IV. Remarks

III. Amendments to the Drawings

Replacement sheets 1, 2, and 3 of the drawings, including changes to Figures 3a, 3b, and 3c, are attached.

Fig. 3A

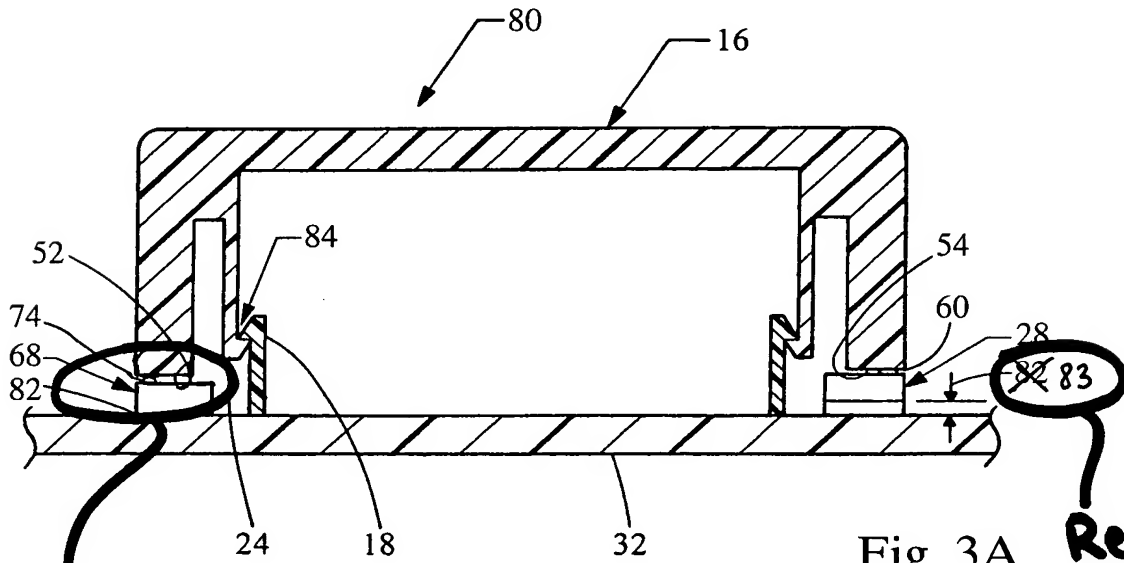
Sheet 2 has been amended to renumber the distance "82" on the right-hand side of Figure 3a as the distance "83". Additionally, the peak 52 in Figure 3a has been lowered to contact the projection 74, as disclosed in Paragraph [0032] of the original Application as filed.

Peak 52 Lowered

Renumber
as 83

Fig. 3B

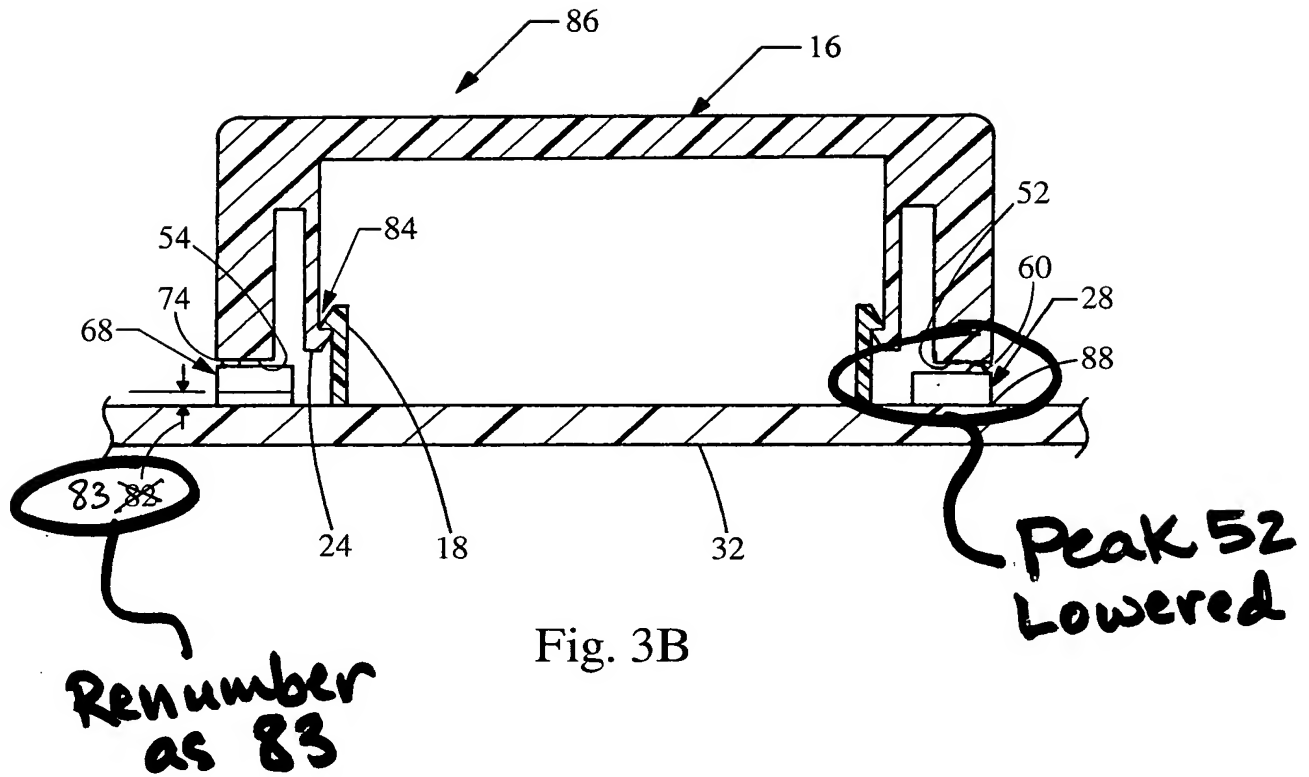
Sheet 3 has been amended to renumber the distance "82" on the left-hand side of Figure 3b as the distance "83". Additionally, the peak 52 in Figure 3b has been lowered to contact the projection 60, as disclosed in Paragraph [0033] of the original Application as filed.

Fig. 3C

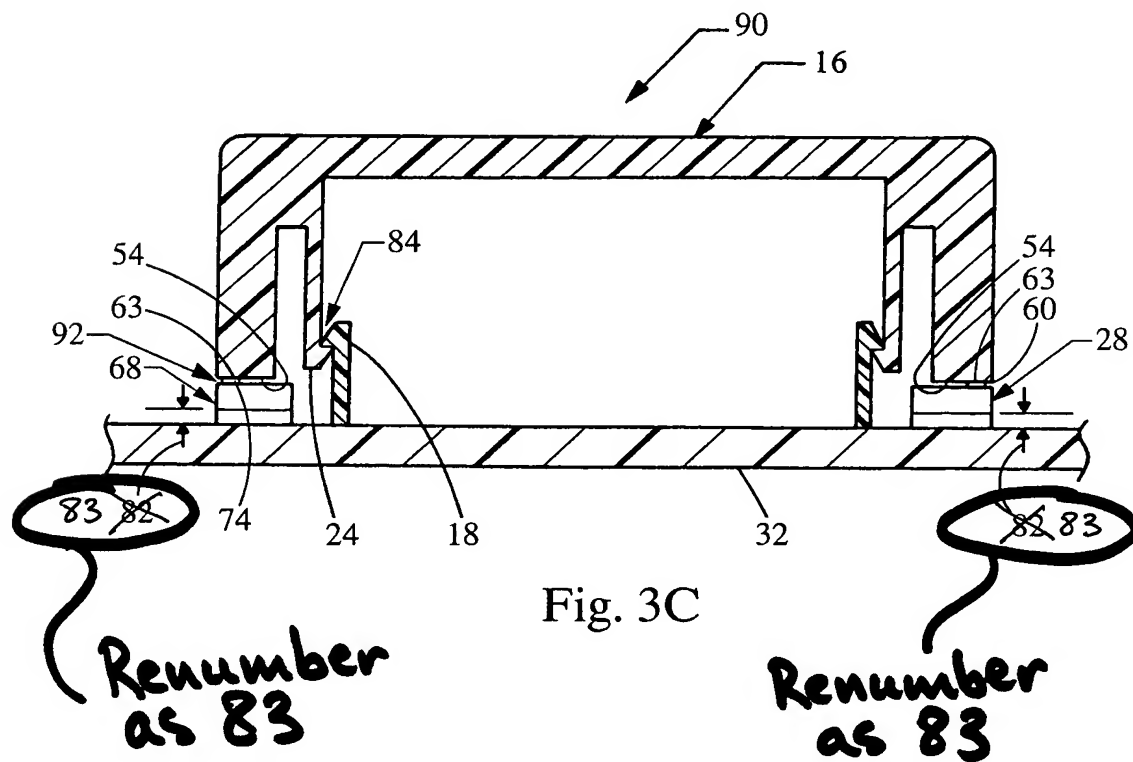
Sheet 3 has also been amended to renumber the distance "82" on both sides of Figure 3c as the distance "83".
